CHANGE ORDER

PROJECT NAME: Edward A. Dufresne Community Center CHANGE ORDER NO: 001
 PPG OCD-DR PROJECT NUMBER: 45PARA3201
 CONTRACTOR: Lamar Contractors, Inc. CONTRACT DATE: 12-7-11

Subject: St. Charles Parish- Community Center
Gustav/Ike Project Number 45PARA3201
Review of Construction Change Order No. 1

project no.	date	drawing number
	4-16-12	ESK002
file name	this drawing modifies	
1003201E200.dwg	E200	
issued for	WCPR #4

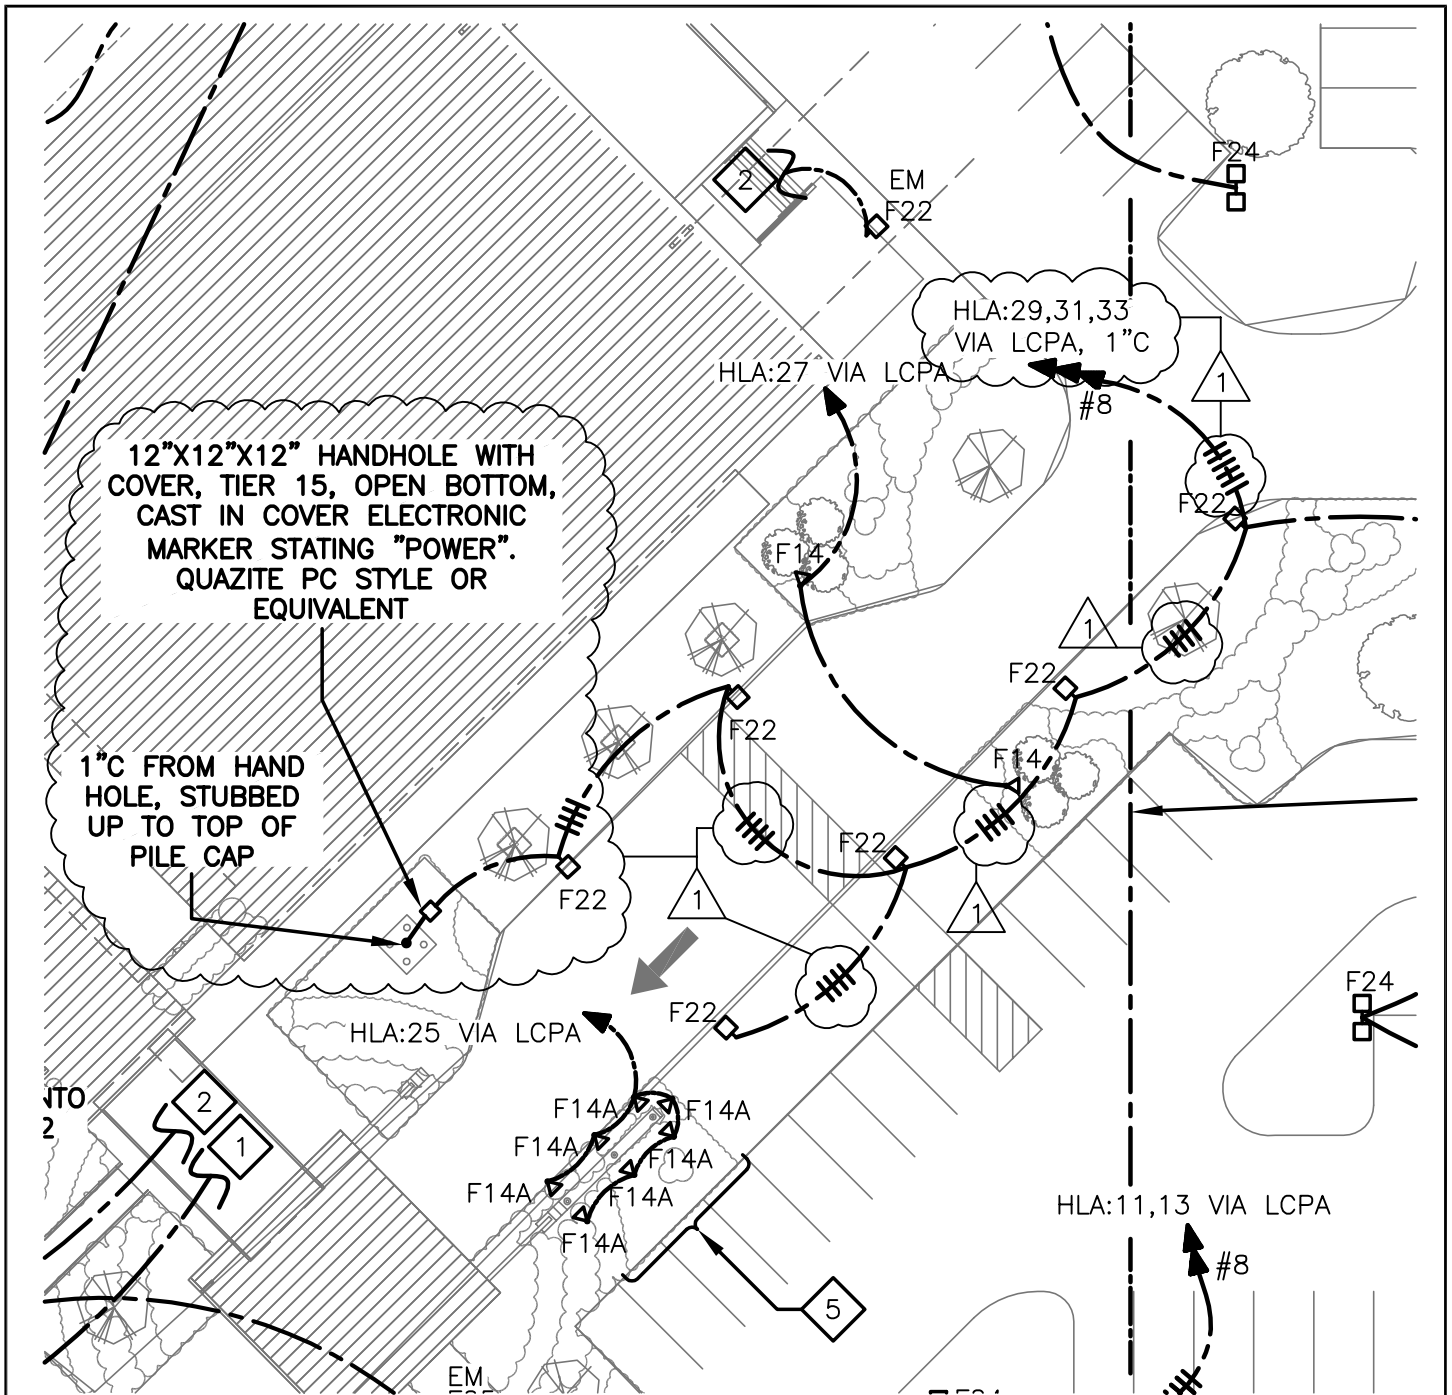
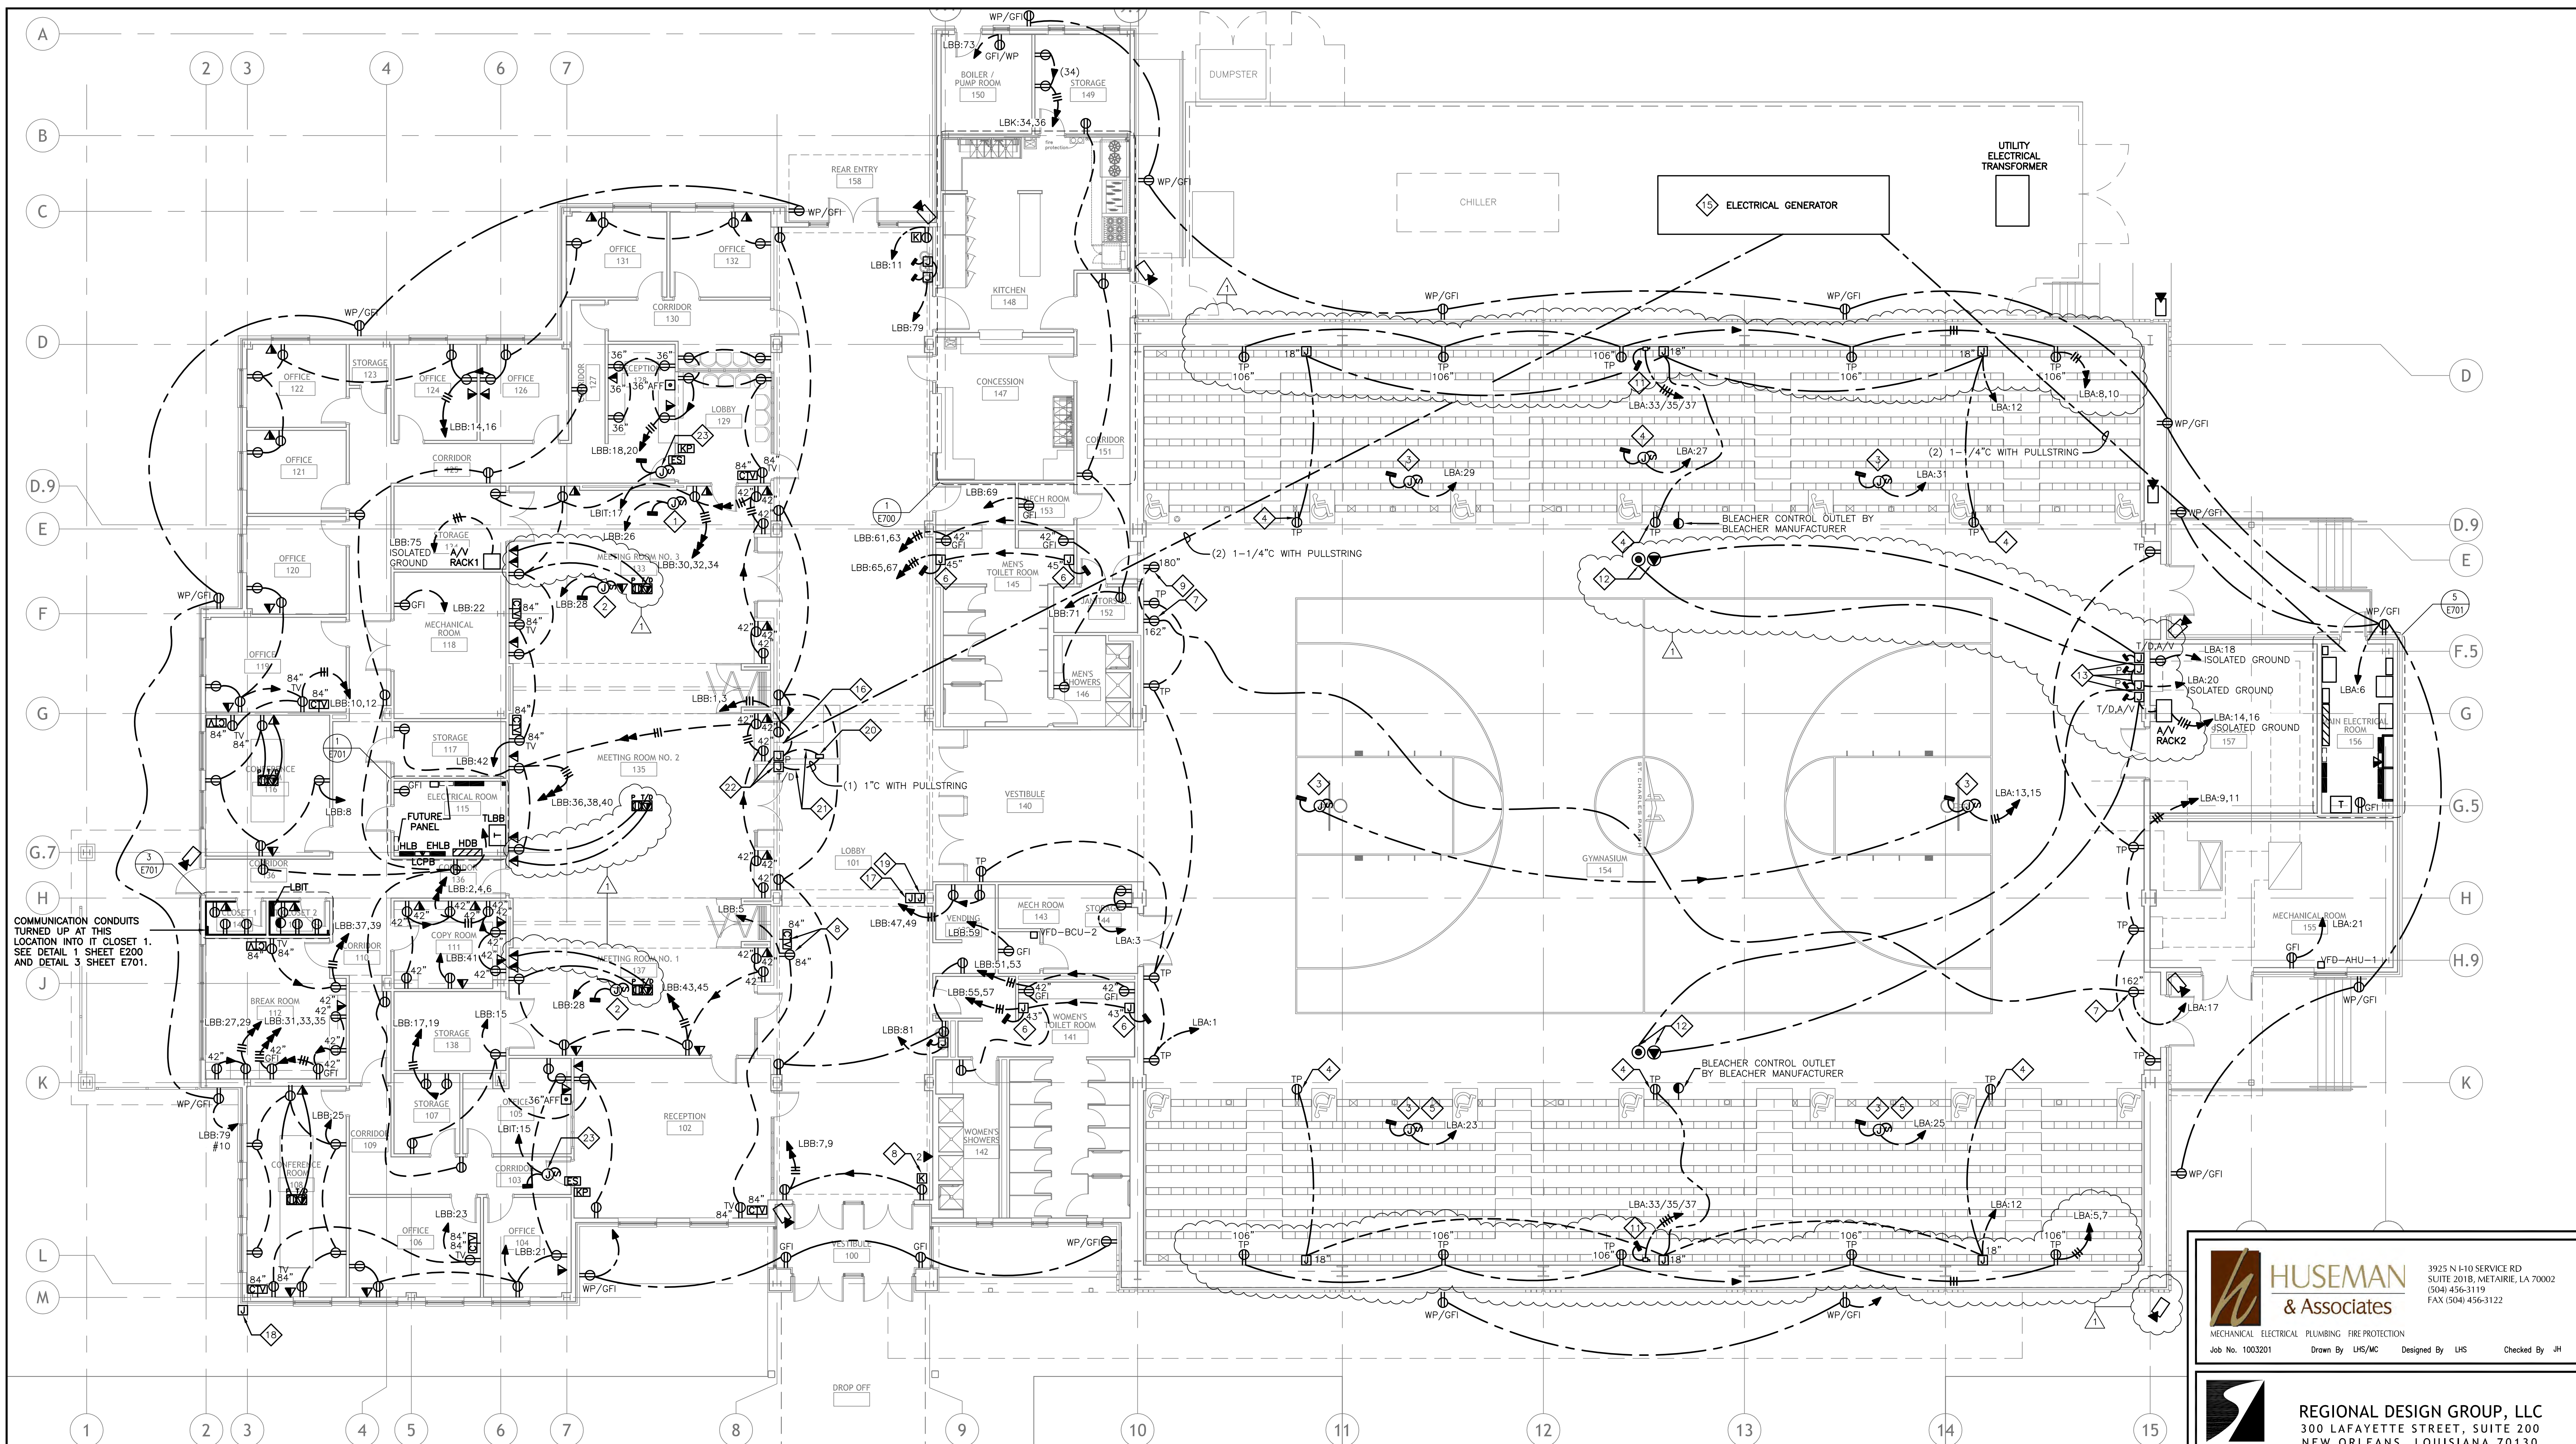
1. SUPPLY AND INSTALL 12 X12 X12 INCH DEEP QUARTZITE BOX WITH 15 COVER AND ADDITIONAL COVER AT LOCATION NEAR FUTURE STATUE LOCATION NOTED ON BLUE PRINT PAGE ESK002.
2. ADD CIRCUIT BREAKER AS REQUIRED.
3. DELETE 1-1/4 LIGHT FIXTURE.

Install additional tel/data power floor outlets in Meeting Room No. 1 (137), Meeting Room No. 2 (135), Meeting Room No. 3 (133), and Gymnasium 154 per attached reissued sheet E301. Install one additional camera for video surveillance at column 15-L.1. Provide credit for the material and labor for the reduction of wall outlets in Gymnasium 154 along columns L.1 and D at 106" above finished floor (AFF). Wall outlets to remain shall be installed in center of each bay at 106" AFF. Install handhole and conduit to accomodate future lighting for proposed statue per attached sketch ESK002.

1	FOOD FACILITIES ARRANGEMENT PLAN	
KSK001	SCALE: 1/4" = 1'-0"	REVISIONS

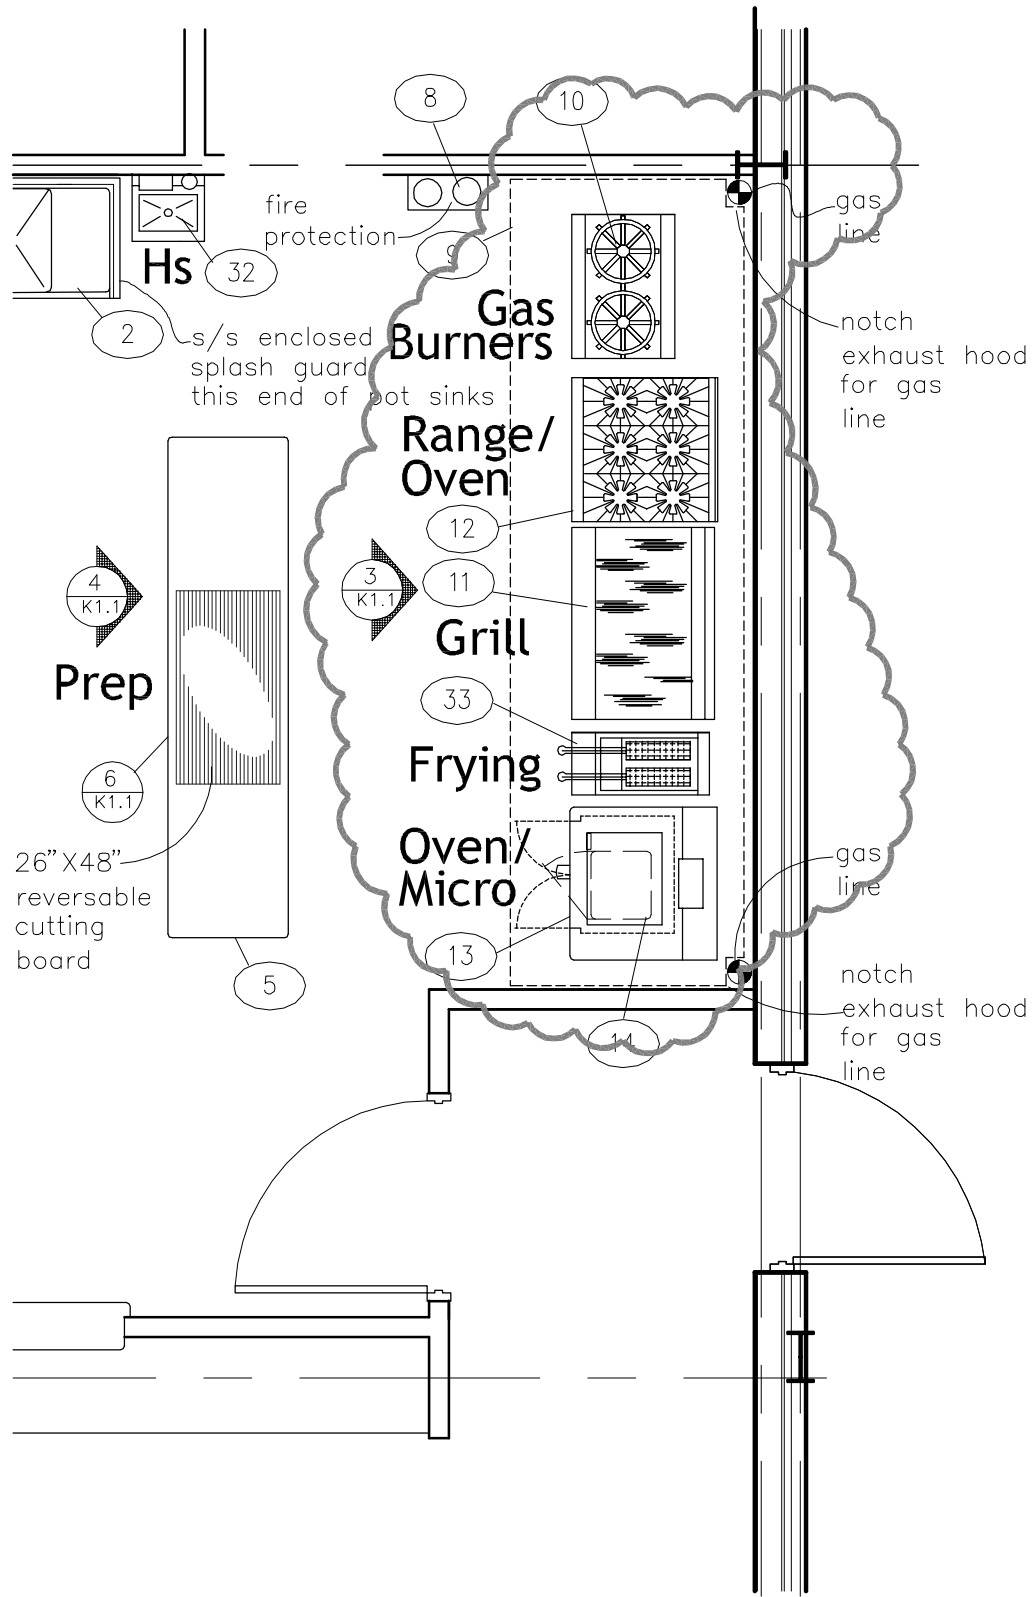
Adjust cookline in Kitchen 148 to allow room for a fryer and revise the three (3) burner stove to a two (2) burner stove per attached drawings. Adjust Natural gas output per Plumbing legend and include one additional connection for new fryer.

NOTE:
 Cookline has been adjusted to allow room for an additional Fryer – Item No.33. Item No. 10 will be revised to a Two (2) burner unit. Adjust cookline to accommodate changes in cookline equipment.
 Fire Protection System nozzles must be adjusted to properly cover all the Equipment under the Exhaust Hood accordingly.

ADDITIONAL REVISED AND NEW EQUIPMENT
 10. TWO (2) BURNER STOCK POT STOVE
 33. FRYER
